RE: MIDWAY BUSINESS PARK LOT 16-A (E-16/D18)
(5941 Midway Park NE)
ENGINEERS CERTIFICATION FOR CERTIFICATE OF OCCUPANCY
ENGINEERS STAMP DATED 4/23/2001
ENGINEERS CERTIFICATION DATED 1/16/2002

**Re: Drainage Report for Office/Warehouse at Midway Park, ZAP E-16
Engineer's Stamp Dated April 23, 2001**

**RE: Grading and Drainage Plan for Lot 16-A, Midway Business Park,
5941 Midway Park Rd., (E16/D18), Engineer stamp dated 4/23/2001.**

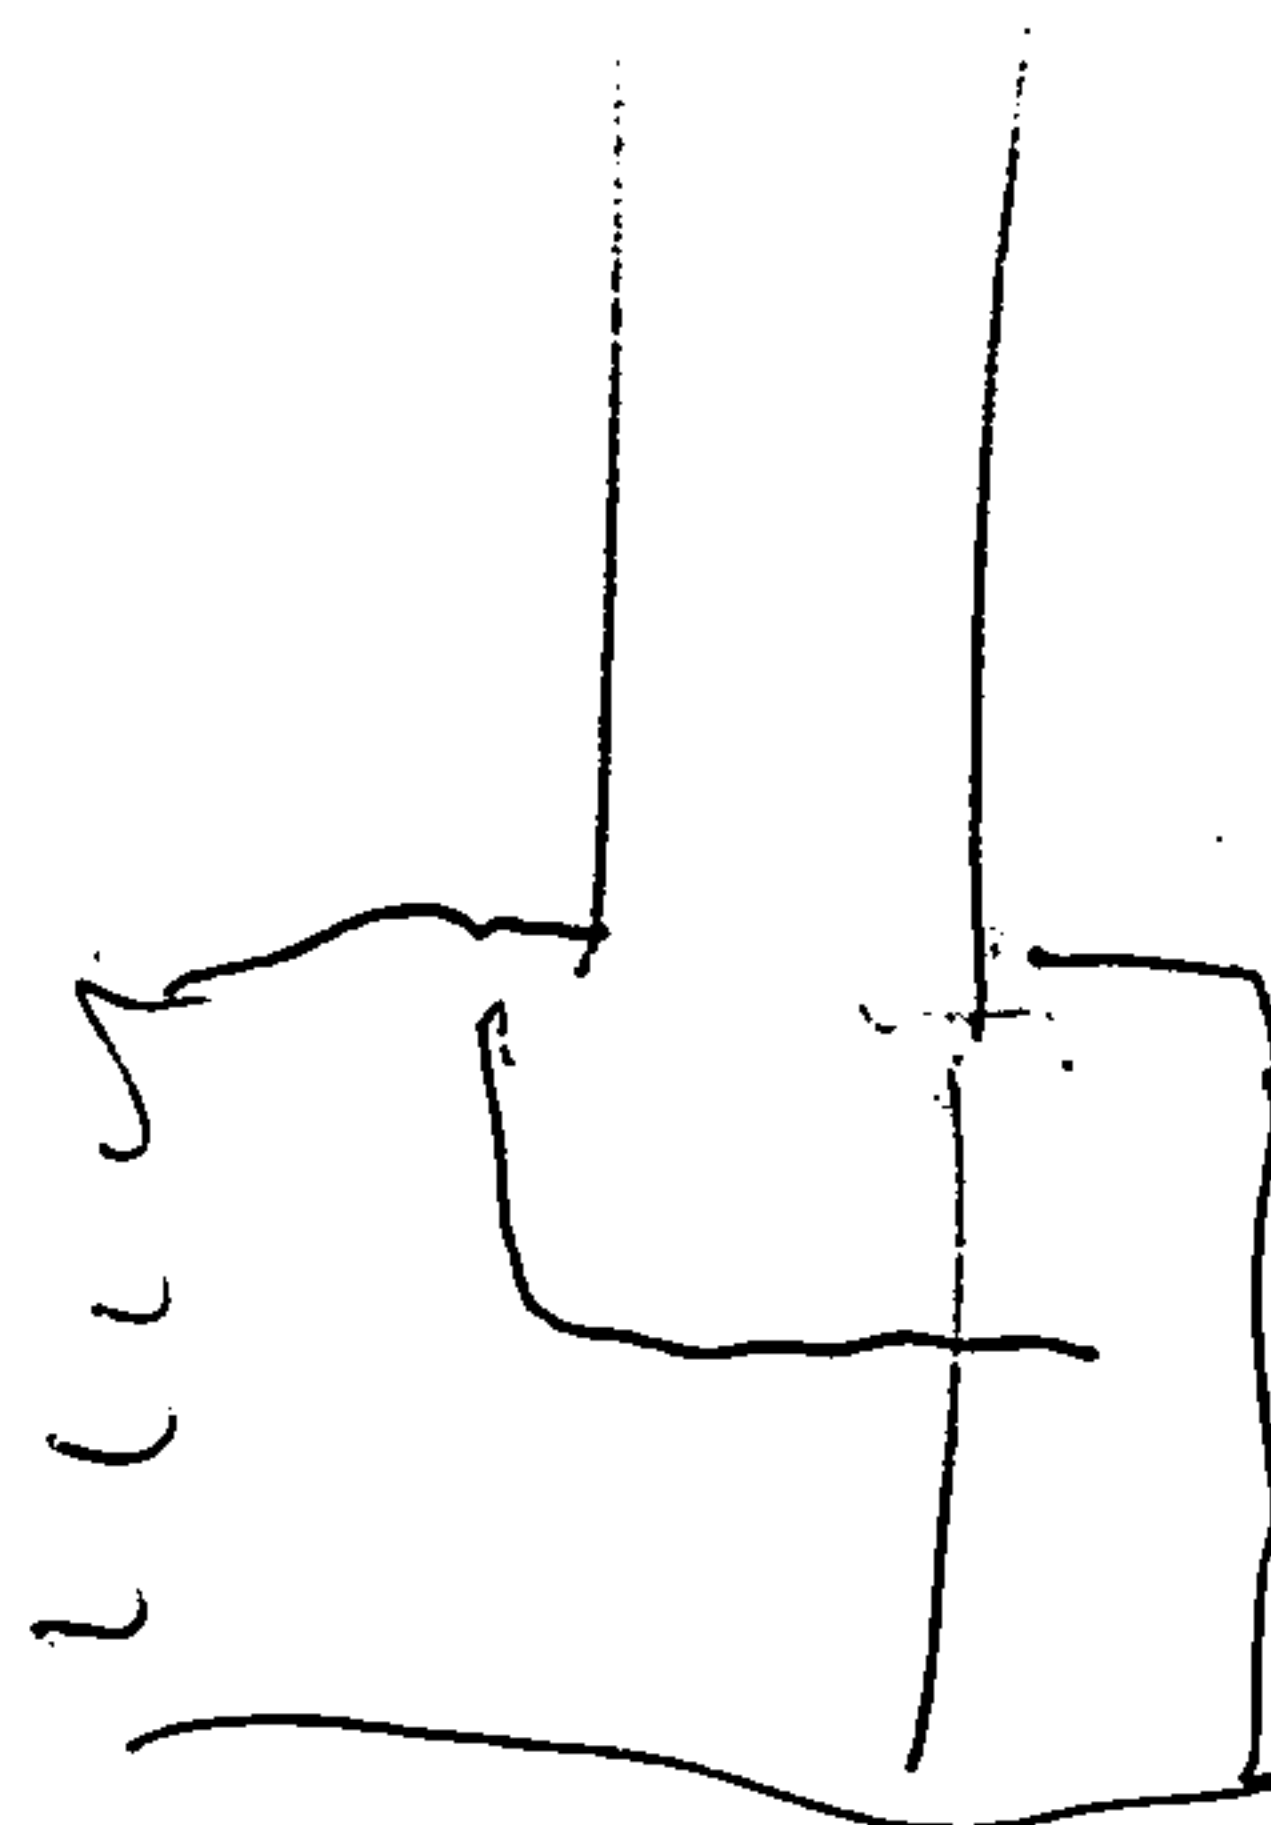
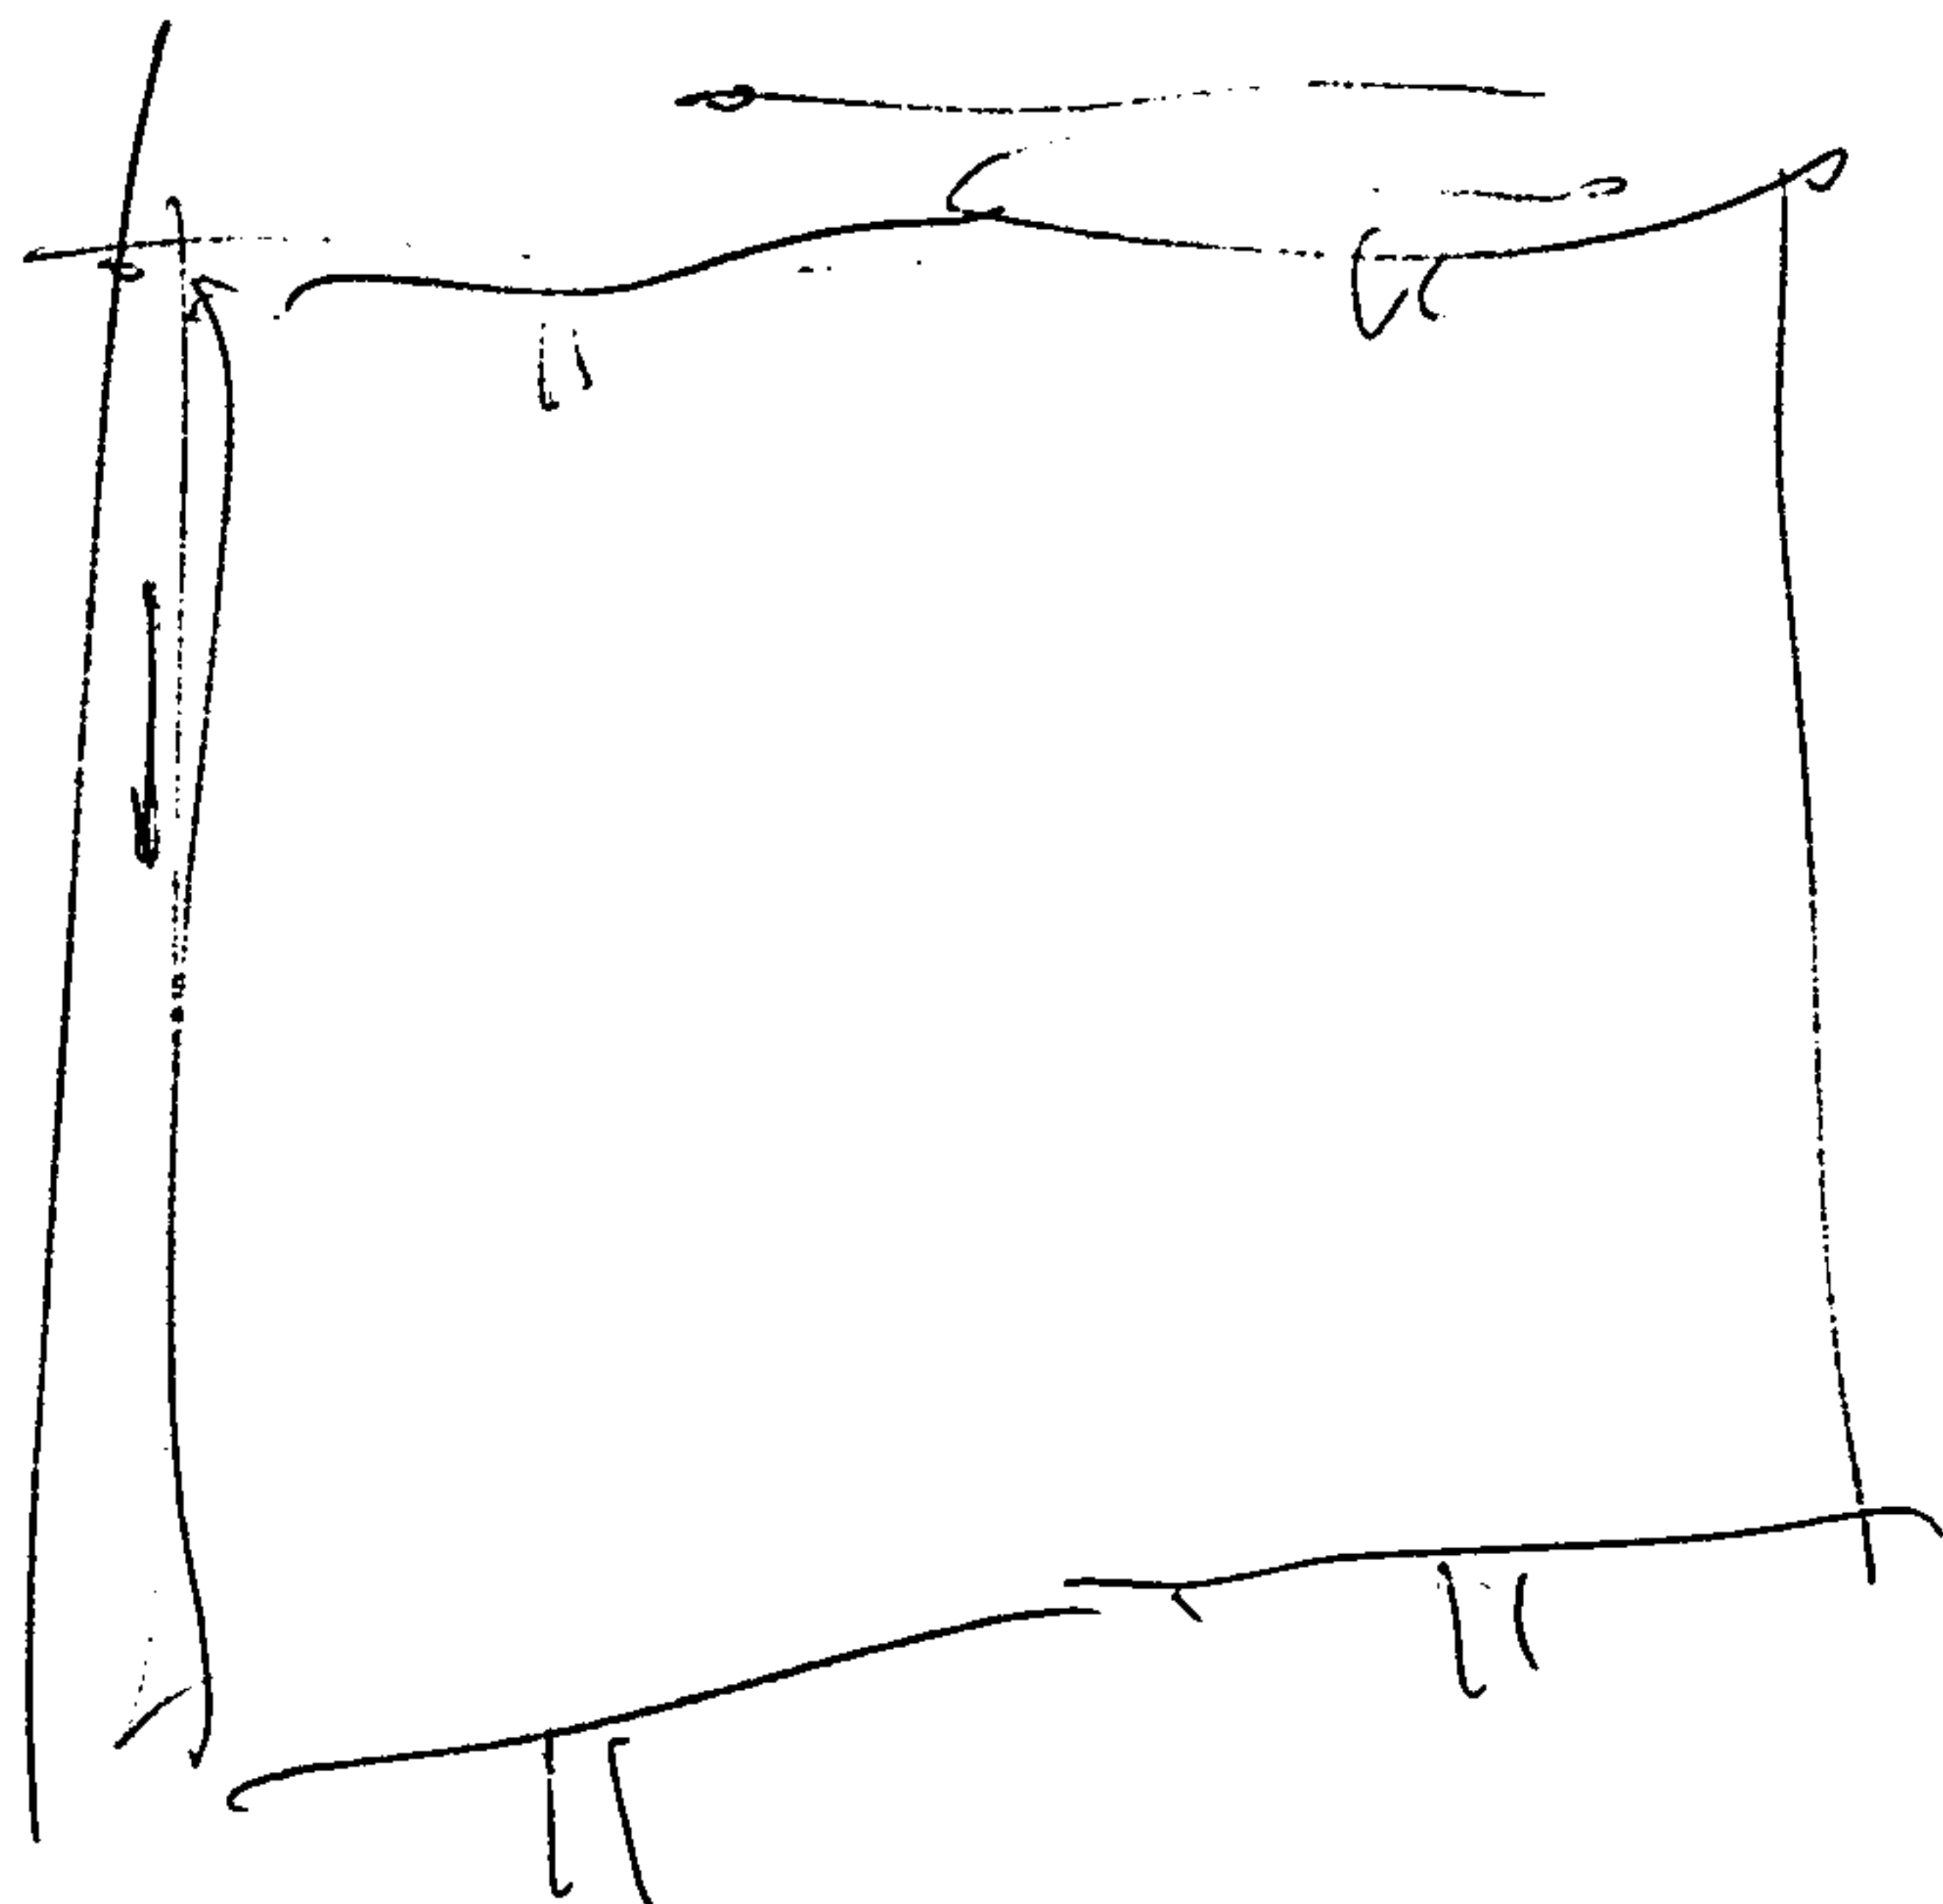
- 
1. Some type of onsite debris basin/oil separator, like the attached Outlet Structure Detail, will be required. A hooded inlet (such as a SNOOT) will also be acceptable. This Best Management Practices (BMP) feature will be maintained by the owner.
 2. The rundowns to the earthen side channel should be concrete to the toe of slope with cutoff walls and riprap protection at the end (see attached detail). Riprap may need to be hand-placed under the bike trail across the earthen channel.
